Technical Journal

Mirror cover, noise

| REF NO: TJ 33170.2.0 | ISSUING DEPARTMENT: Technical Service | | ARKET: s and Canada |

| Title | Inner rear view mirror | Page | 1 (4) |

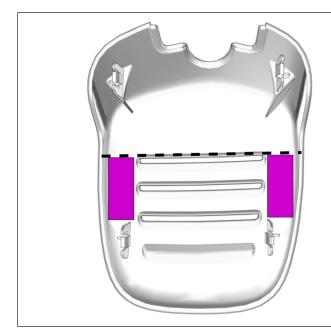
* Install two foam pieces (p/n 30649094) in mirror cover according to method in "TJ33170.pdf"

Install the marked components.

Note! Ensure that the tape is fixed to the surface.
